Municipality of Anchorage

Memorandum

Date: February 29, 2024
Subject: Fairview PEL
To: Seward-Glenn Planning & Environmental Linkages (PEL) Team
Through: Craig Lyon, Planning Director
Through: Ryan Yelle, Long Range Planning Manager
From: Daniel Mckenna-Foster, Senior Planner, Long Range Planning

Total Acreage Affected (Preliminary Analysis)

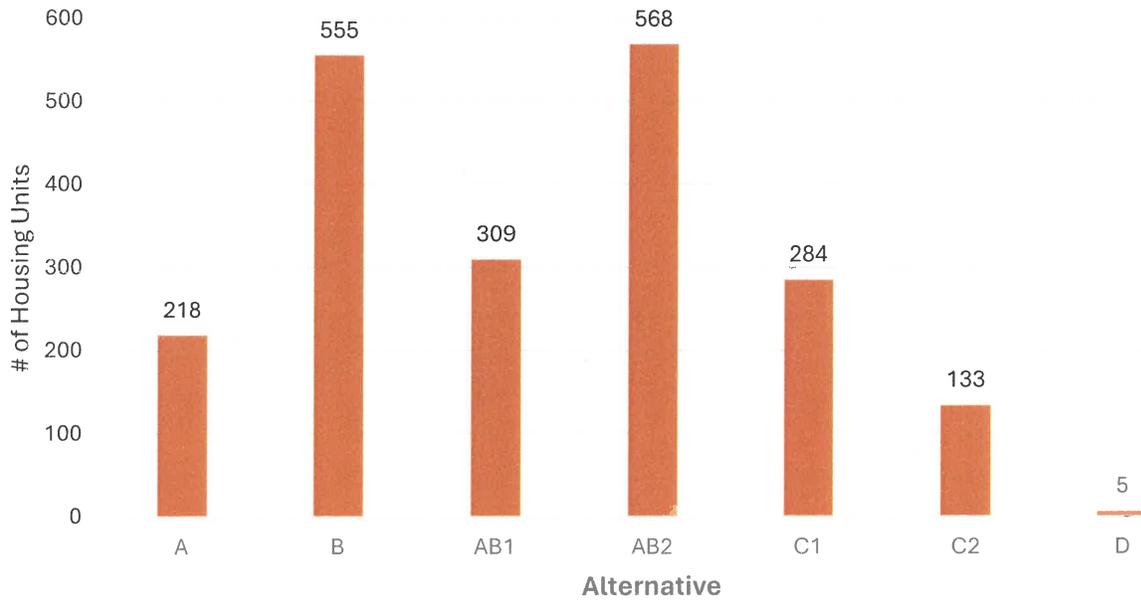
An intersection analysis of available mapping layers for project design alternatives and MOA parcel data indicates that all presented design alternatives would have significant impacts on acreage, housing units, loss of net taxable value, and zoning capacity. The charts below highlight the results of this preliminary review:
